## Accessibility Design Review Report

St. Michael's Uniting Church  
120 Collins Street  
Melbourne, Victoria

Dated: 09 December 2024

Reference: EG-241208-AC

**2** Proposed Internal Elevations  
R.G-02 East Lobby - Elevation 2  
1: 25 @ A1

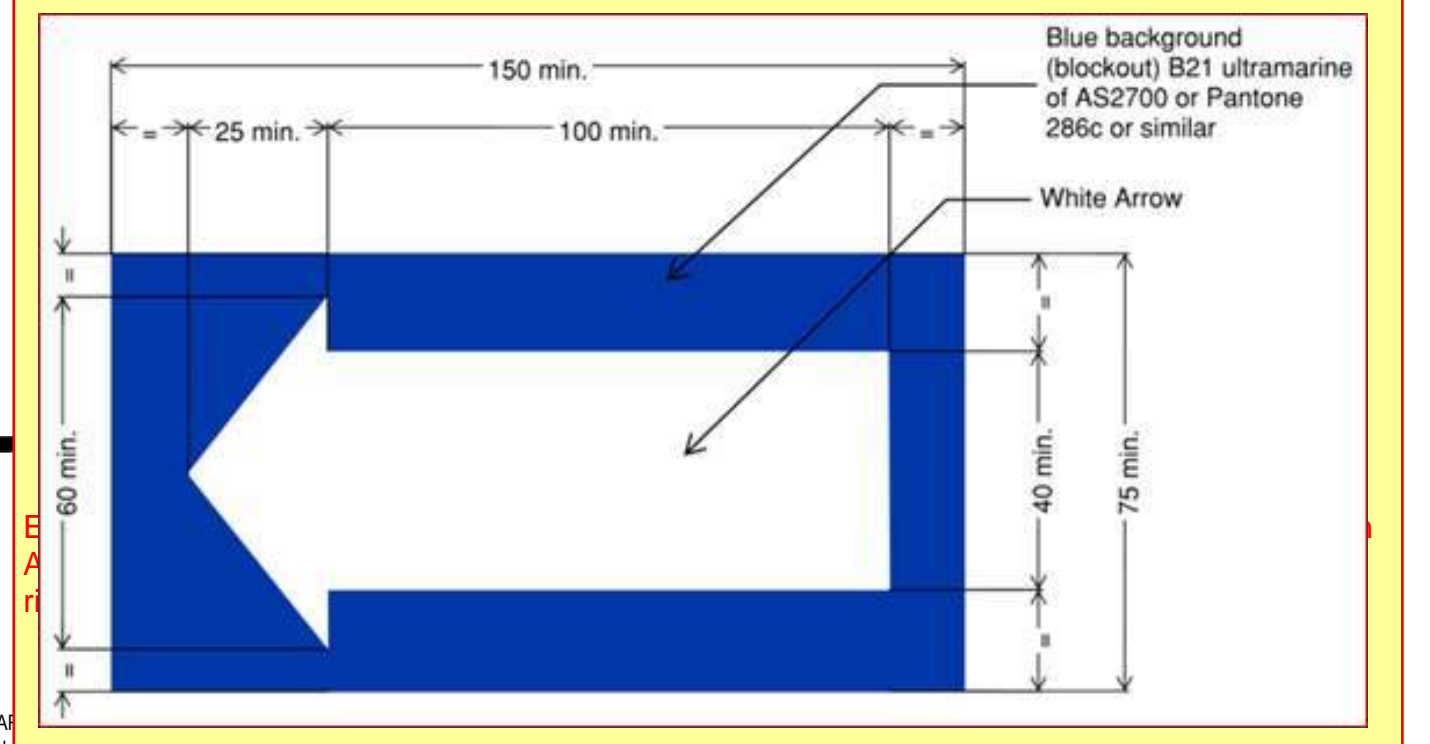
Signage must be visible on both sides of the automatic sliding door in accordance with AS 5007. The expected signs are shown below (in accordance with AS 5007).

PROPOSED - EAST LOBBY

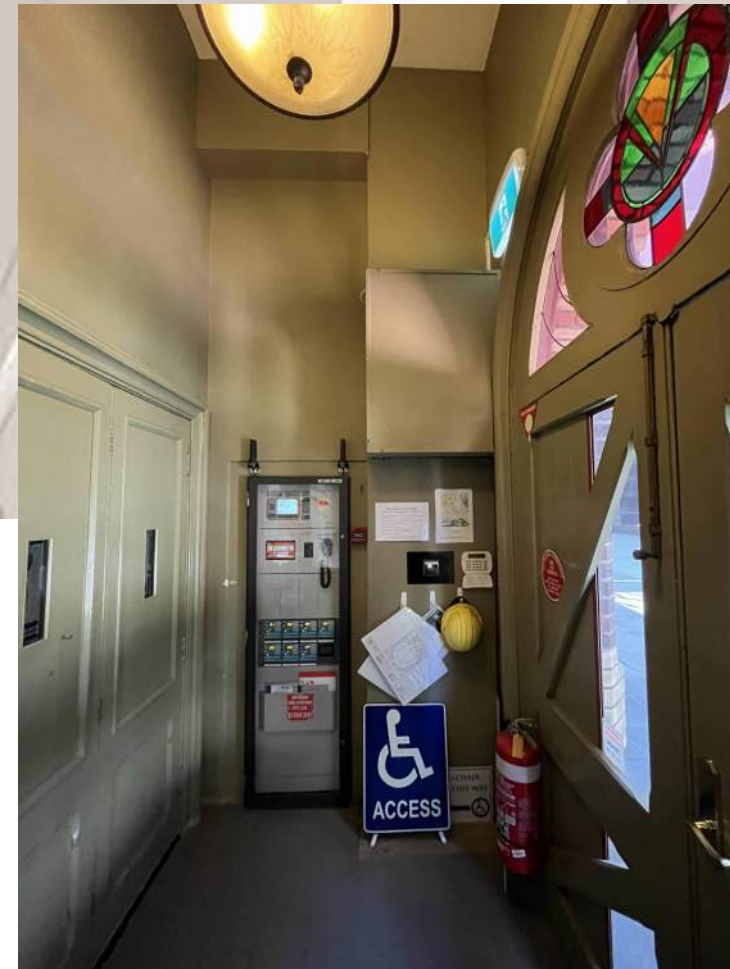
We recommend a minimum 30% luminance contrast between a 150mm high skirting board at the base of each wall, and the wall surface. High-contrasting skirting boards will assist people with low vision to identify perimeters of corridors and accessible spaces.

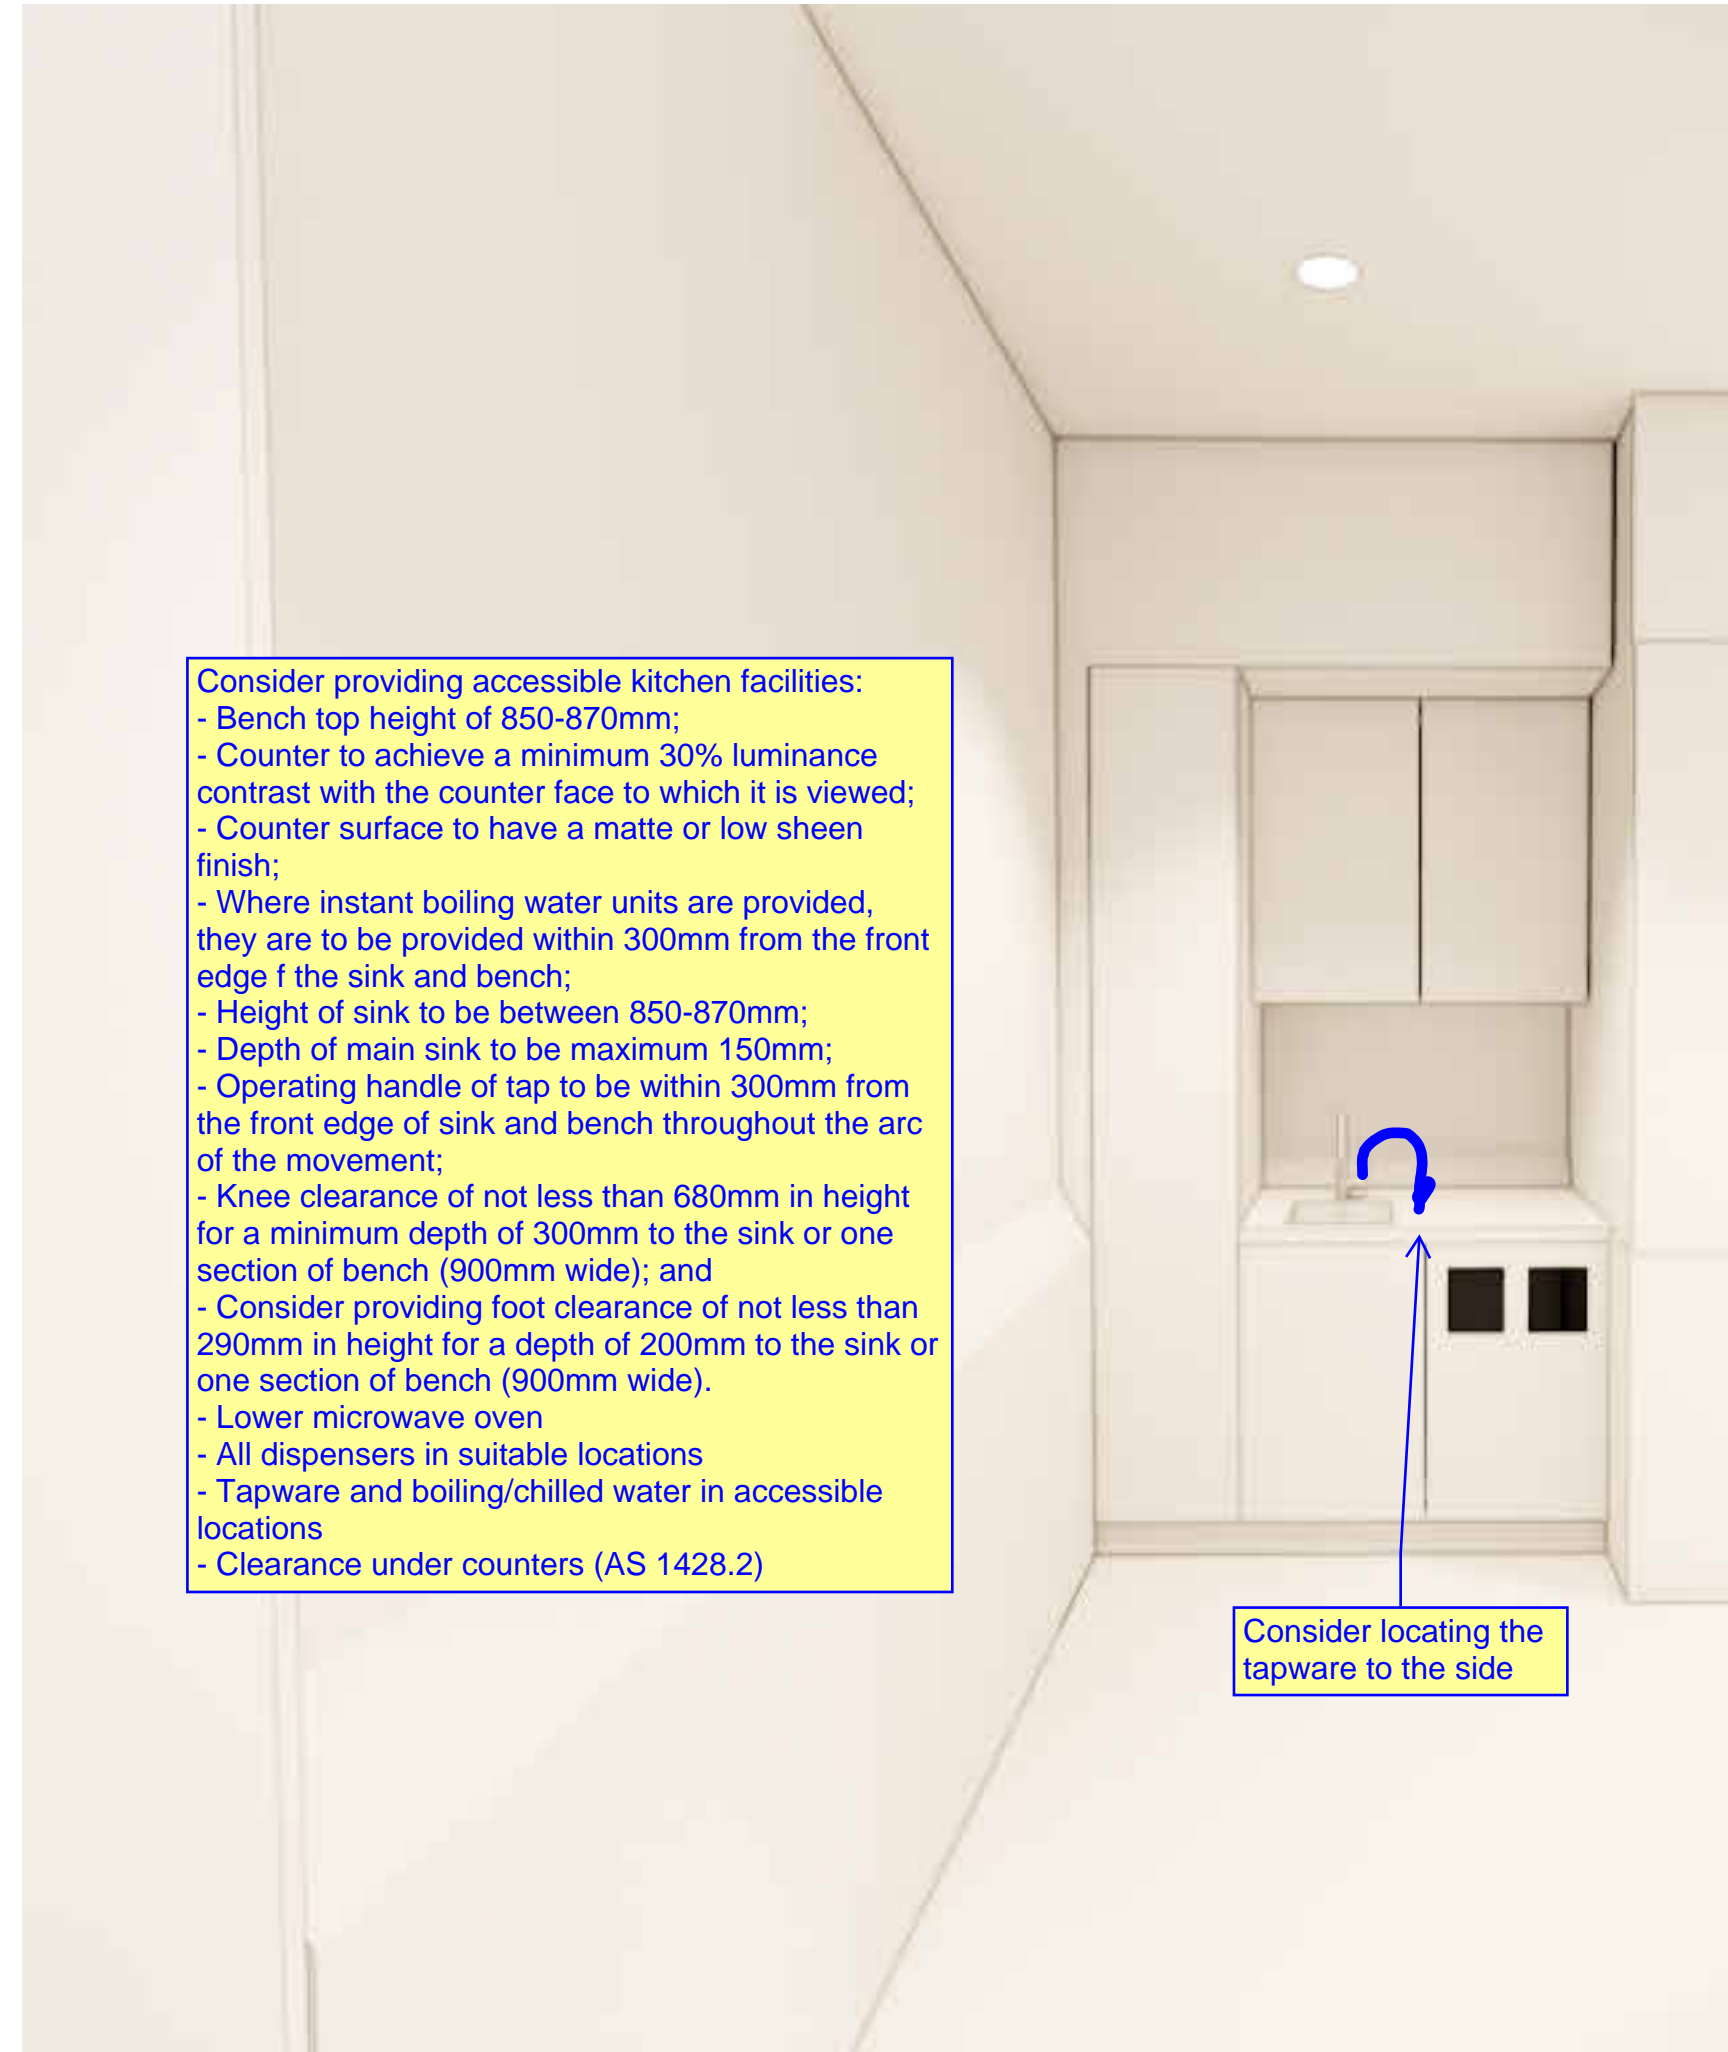
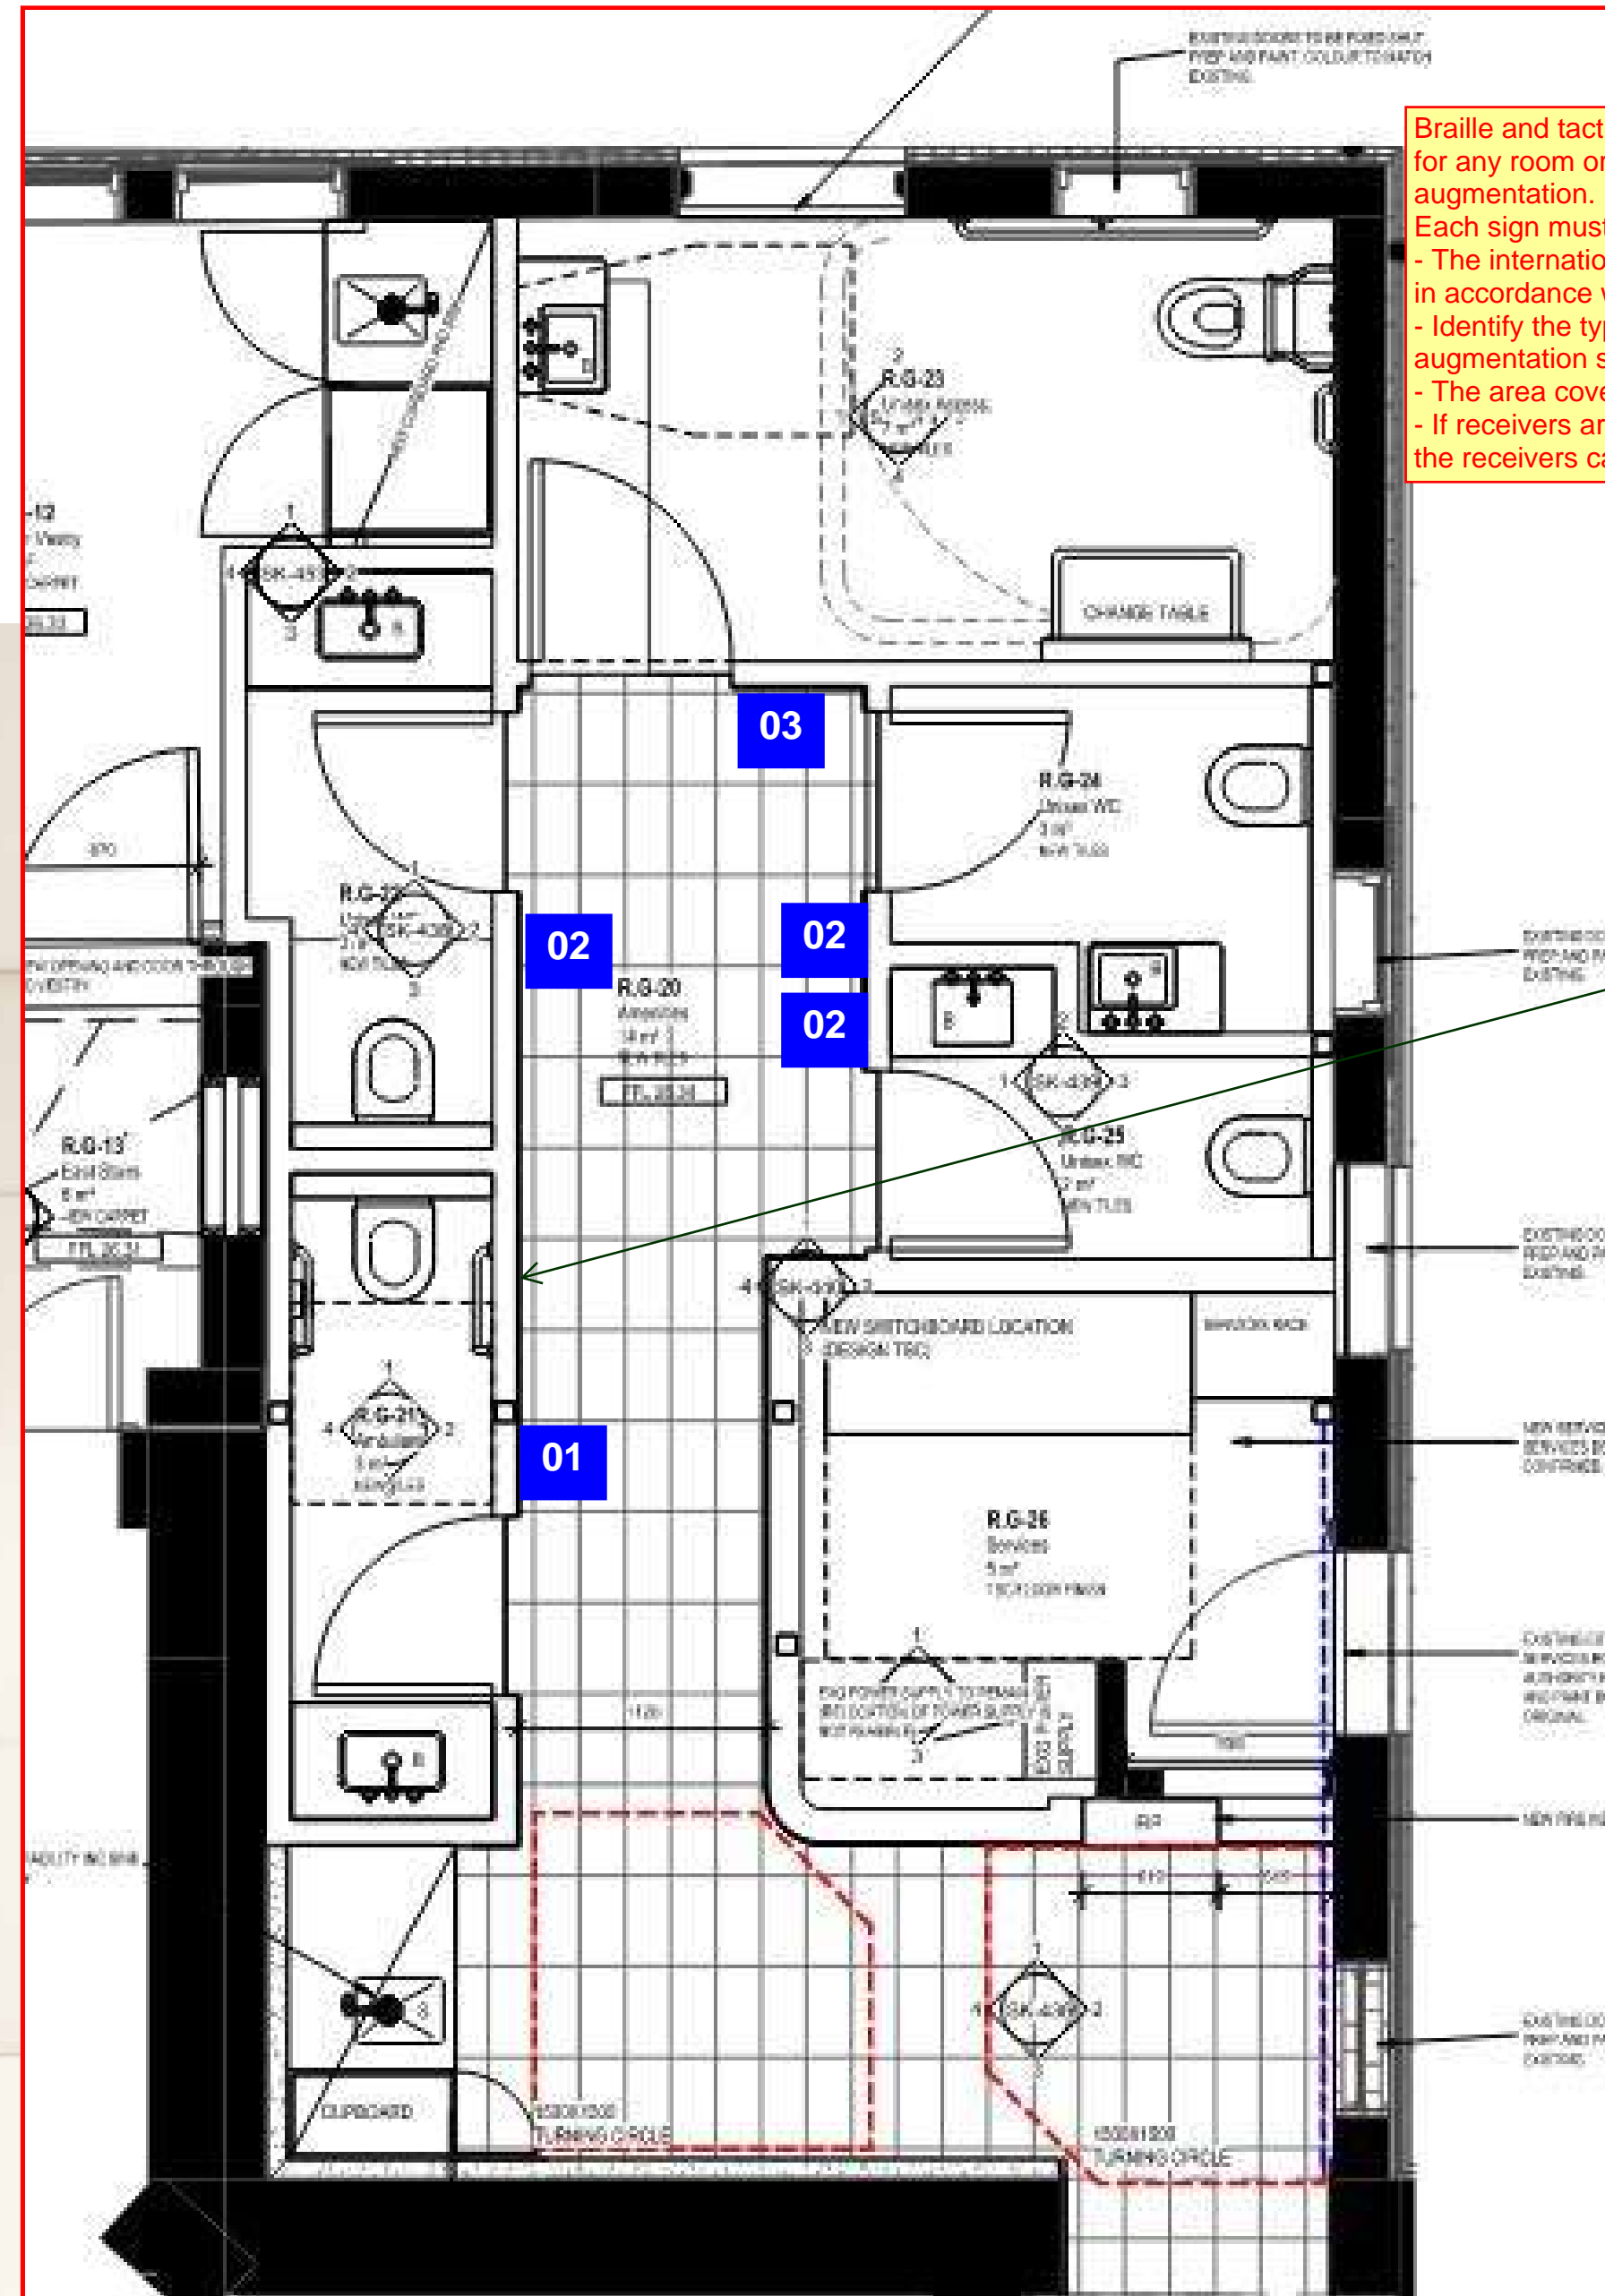
Consider providing accessible kitchen facilities:

- Lower microwave oven
- All dispensers in suitable locations
- Tapware and boiling/chilled water in accessible locations
- Clearance under counters (AS 1428.2)

Consider locating the tapware to the side

Braille and tactile signage is required for any room or space with hearing augmentation.
